HISTORIC AND DESIGN REVIEW COMMISSION

HDRC CASE NO: 2015-092
ADDRESS: 223 E SUMMIT
LEGAL DESCRIPTION: NCB 6882 BLK 1 LOT 1 OUR LADY OF GRACE SUBD
ZONING: R4 H
CITY COUNCIL DIST.: 1
DISTRICT: Monte Vista Historic District
APPLICANT: Ramiro Zapata
OWNER: Gustavo Garcia-Siller
TYPE OF WORK: Construct addition, new parking area and ADA improvements

Our Lady of Grace Activity Center Addition and Renovation

REVISED 1ST FLOOR PLAN
SCALE: 1/8" = 1'-0"

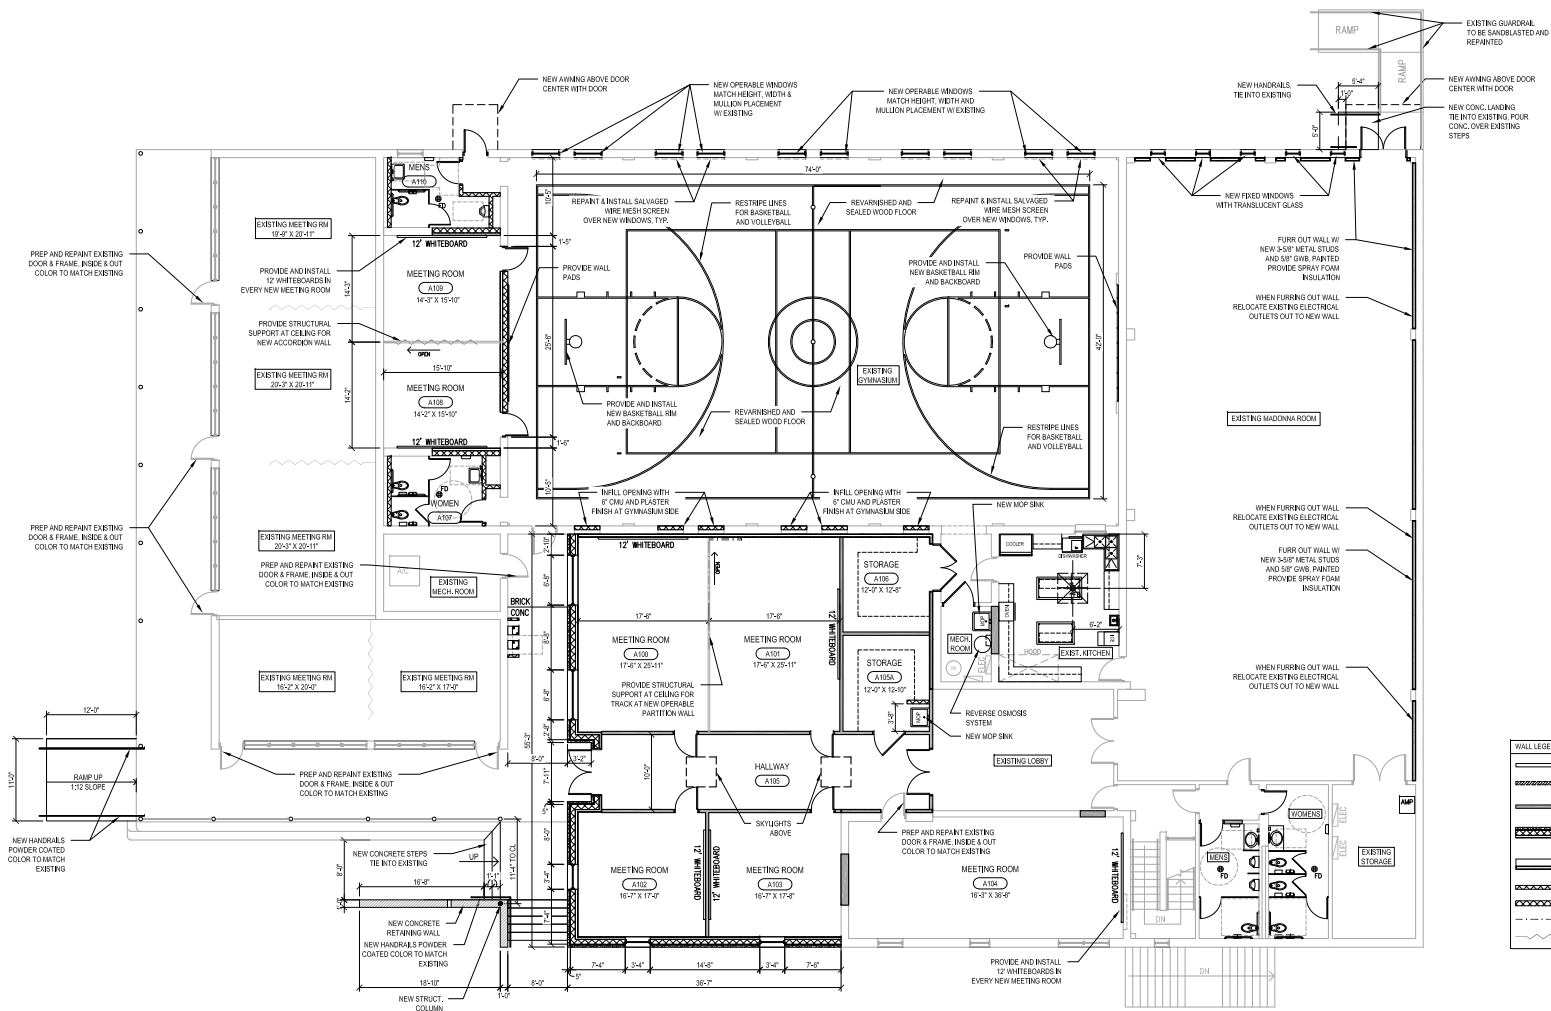
- d. New additions should be clearly identified as new according to the Guidelines for Additions. The proposed stone cladding will match the existing walls of the building and blend in with the original wall to the east. However, the proposed massing which is set below the main building volume and is separated on the west side by the existing canopy breaks the mass and provides a clear differentiation between new and old.

- f. According to the Guidelines for Site Elements, new parking areas should be screened from view. The proposed design does not incorporate any screening which is not consistent with the guidelines.

- h. Consistent with the Guidelines for Site Elements, new ramps should be unobtrusive and minimize visual impact. In addition, ramps should be screened from view using landscape materials. The proposed ramp does not obstruct view of any historic structure; however no screening has been proposed which is not consistent with the guidelines.

Staff recommends approval of item 2 based on findings d-e with the stipulation that the new parking area is screened from view.

Staff recommends approval of item 4 based on finding g with the stipulation that the new ramp is screened from view.
